CE2D-2-23

Original Proposal

IECC CE: SECTION 202

2024 International Energy Code[CE Project] R3

Figure 1. Heat pump chiller piped in series

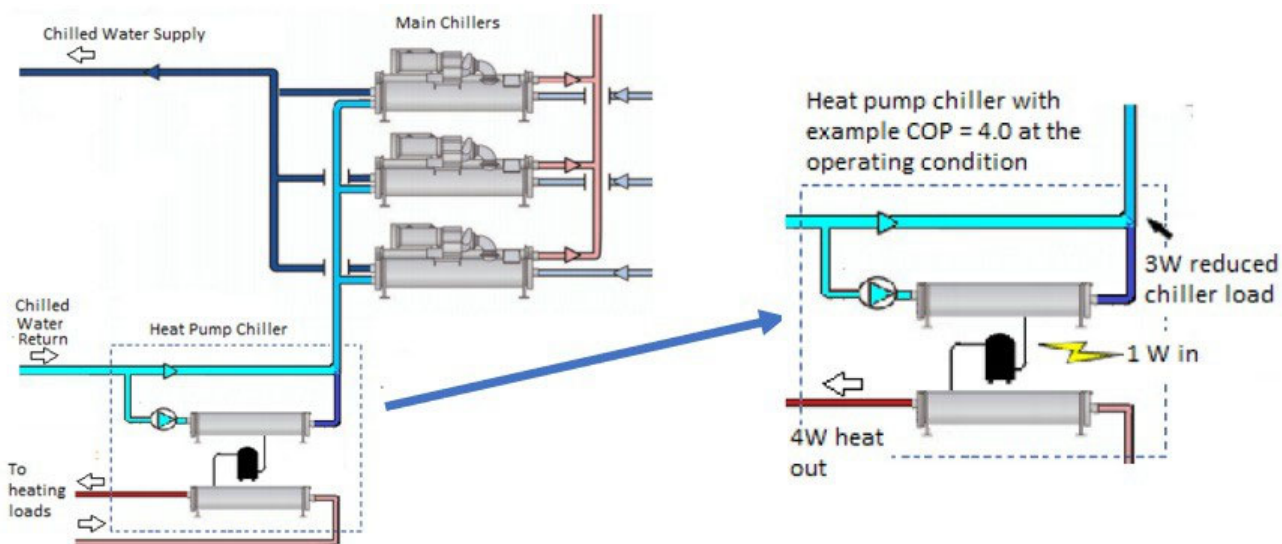
**Reason:** Section C403.11.6, "Heat Recovery for Space Conditioning in Healthcare Facilities," requires heat recovery in most acute inpatient hospitals. The existing language refers to "condenser heat recovery." The heat source was intended to be the chilled water return, and the economic justification was built on that. The diagram shows a parallel and in-series system. Both are acceptable ways to meet the requirement.

Fig. 2: Cost-effectiveness analysis using PNNL data

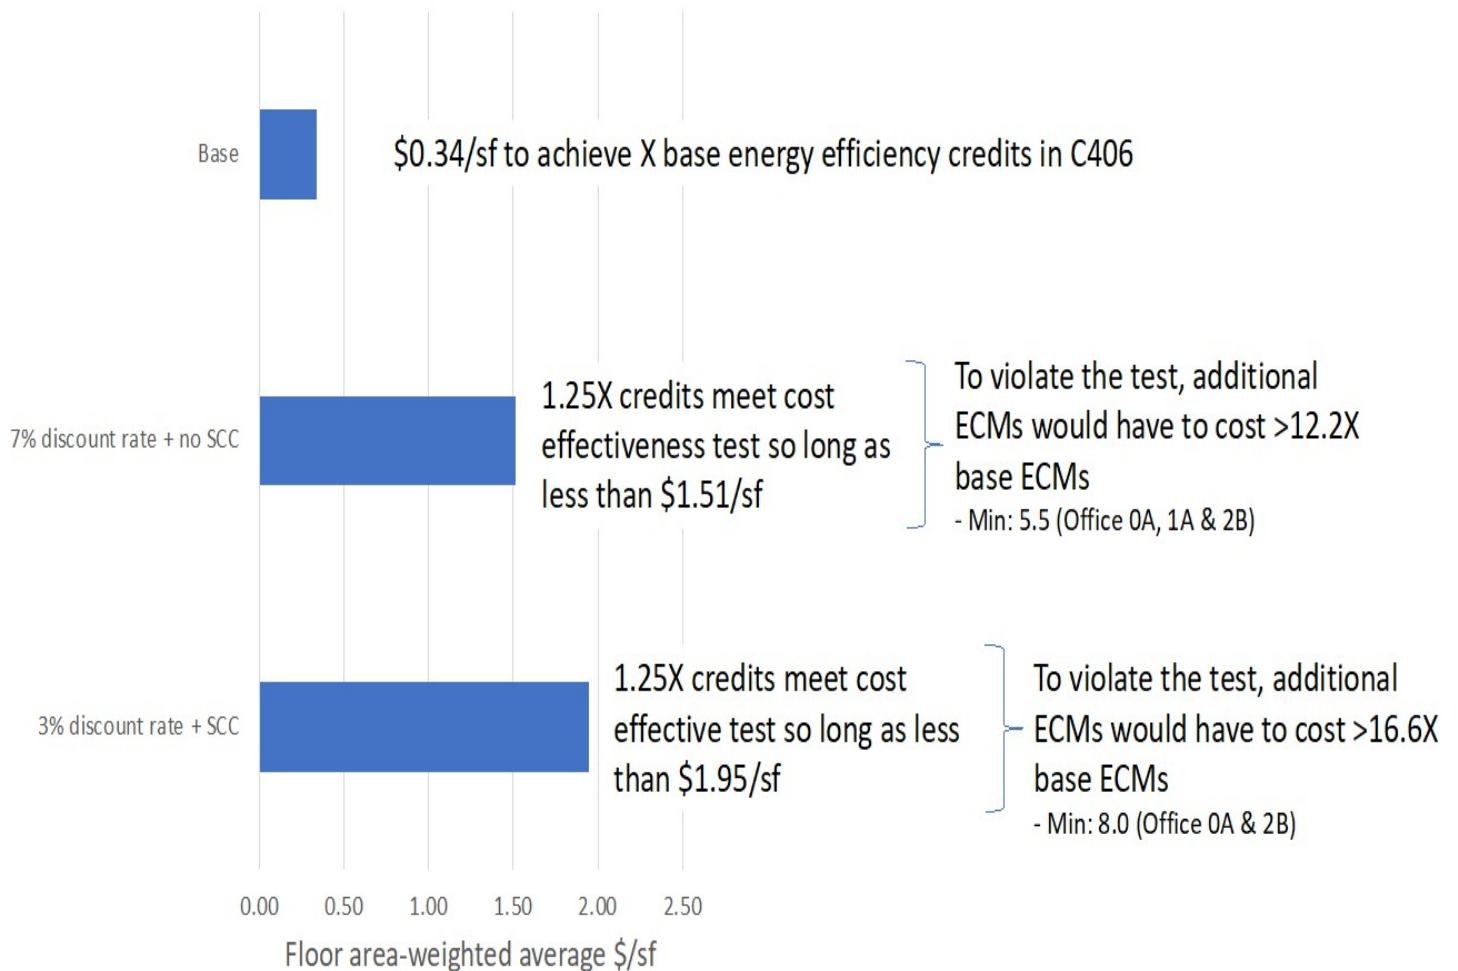
In addition to the base cost-effectiveness analysis support, the Commercial Consensus Committee provided the option of including a social cost of carbon in cost-effectiveness calculations. PNNL also did not do calculations showing what that high-efficiency cost-effective credit package level would be with a SCC. Further, there is mounting evidence supporting a SCC more than 3X higher than that recommended by the Committee, which warrants further consideration.

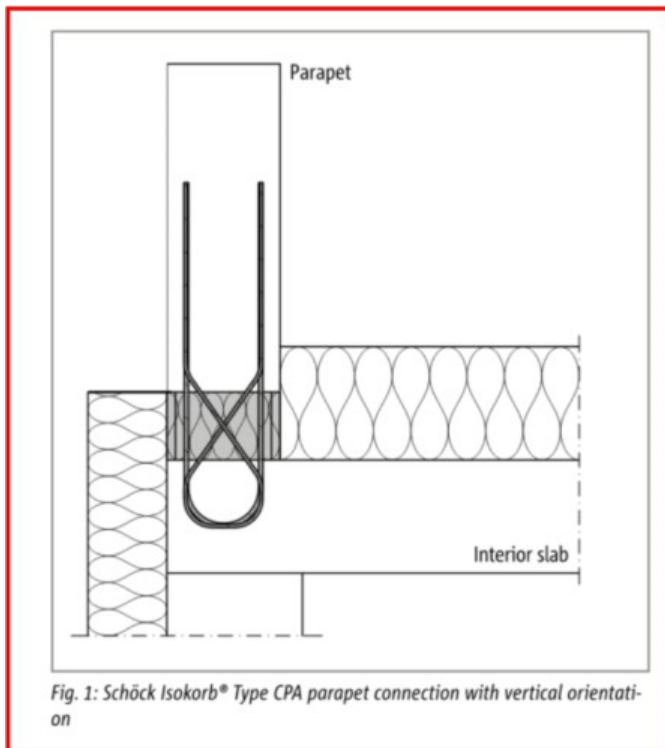
The proposed wording will make it feasible to meet thermal performance requirements with current structural thermal break products on the market.

The tweaks to the wording clarify that a manufactured structural thermal break is acceptable and that the R-value applies only to the **insulated material** of the manufactured assemblies.

ISOKORB T TYPE CPA: STRUCTURALLY ANCHORS THE PARAPET INTO THE TERRACE/ROOF SLAB AND MAINTAINS CONTINUOUS INSULATION THROUGH THE PARAPET

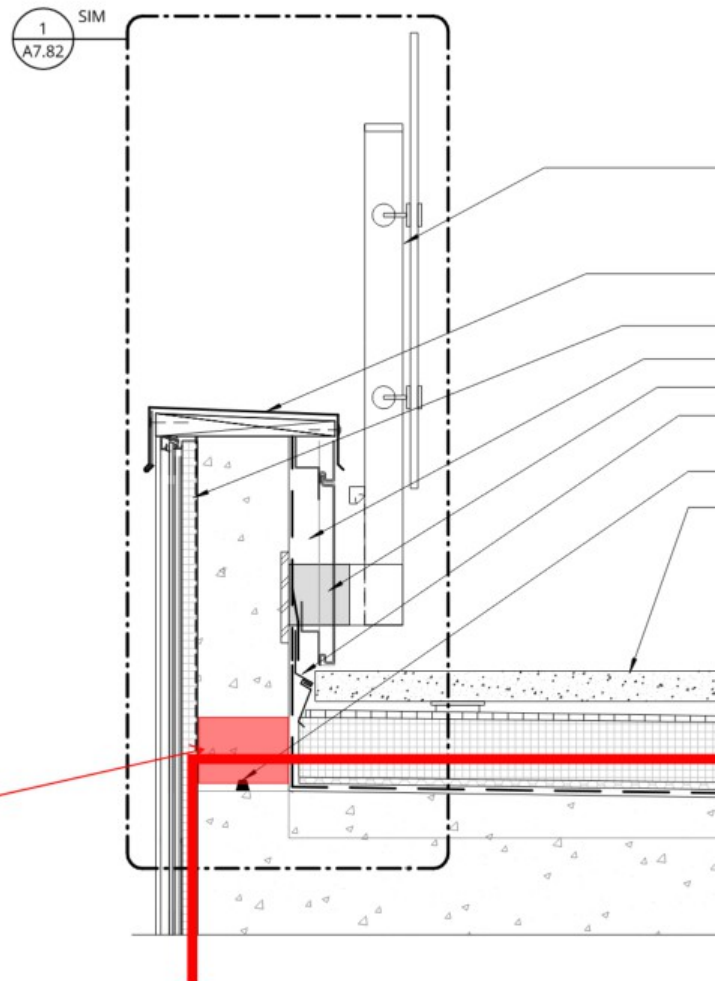
Regarding parapets with adding C402.7.5.5, incorporating a structural thermal break within the parapet ensures a truly continuous building envelope compared to extending insulation 2' up along the parapet.

See below image for where a structural thermal break can be incorporated at a parapet to maintain continuous insulation:

Fig. 18. HVAC energy simulation results of the medium office building per ASHRAE Standard 90.1 – 2016.

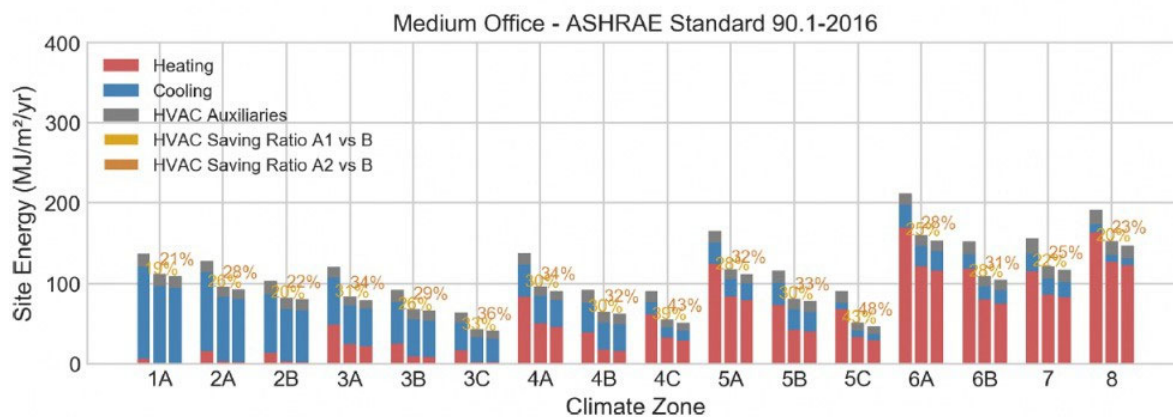
These projects compared a Baseline Case with no occupancy sensing, Advanced Case I with occupancy presence sensing, and Advanced Case II with occupant counting sensing. Advanced Case I is essentially occupied-standby control (turn off ventilation when no one is in the zone) and Advanced Case II is occupied standby control plus demand control ventilation (reduce ventilation based on the number of people in the zone and turn off ventilation when no one is in the zone). The following figure is from the Pang et al paper for the medium office building prototype simulated in the IECC climate zones. The three bars in each climate zone correspond to the baseline case, Advanced Case I, and Advanced Case II from left to right. The yellow and orange texts on top of the bars show the HVAC energy saving fractions of Advanced Case I and Advanced Case II against the baseline. These savings range from 19% to 43% of total HVAC site energy consumption.

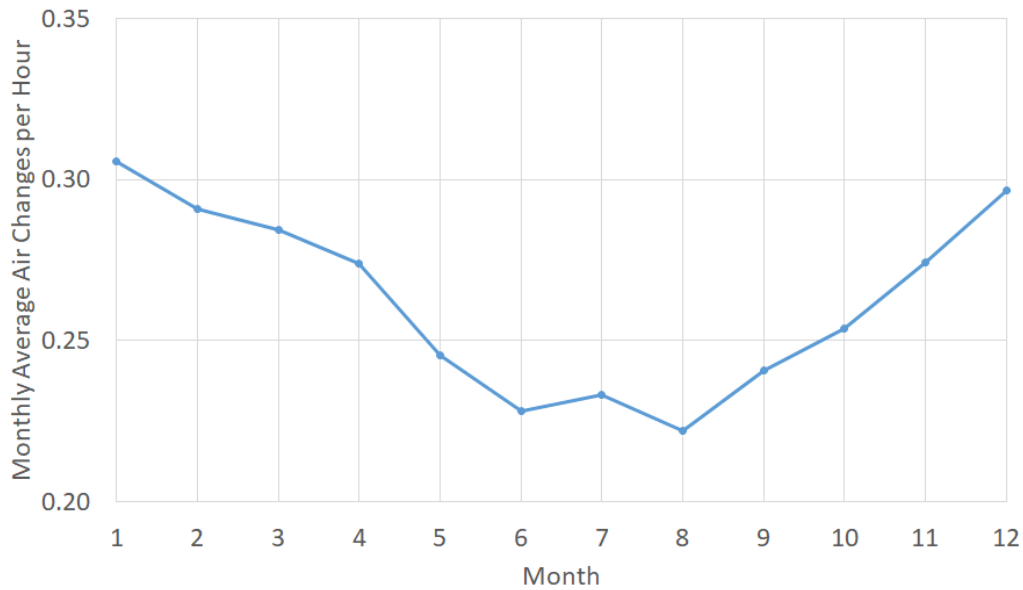
**Reason:** This proposal removes a conflict between the H/ERV fan efficacy of this section and that of Table R403.6.2 (removing the requirement here to ensure that the higher fan efficacy of R403.6.2 takes precedent), clarifies that performance values should be *listed* values (and for SRE, uses the same reference temperature as is required in Section R403.6.1), permits recirculation defrost to be used in all climate zones but Climate Zone 8, and improves readability of the section.

Recirculation defrost draws a fraction of the electrical load of an H/ERV that uses electric resistance defrost, which is a strategy that designers may specify to meet the current Section R408.2.5 requirements. In fact, electric resistance defrost can draw over 900 Watts in a typical unit. A common criticism of recirculation defrost is that it reduces air exchange when installed in cold climates that require frequent operation of the defrost cycle – leaving occupants without access to fresh air. However, by overlaying a typical recirculation defrost control strategy on a TMY3 weather data for each climate zone, we can see that recirculation defrost cycles are very limited on an annual basis, even in cold climates:
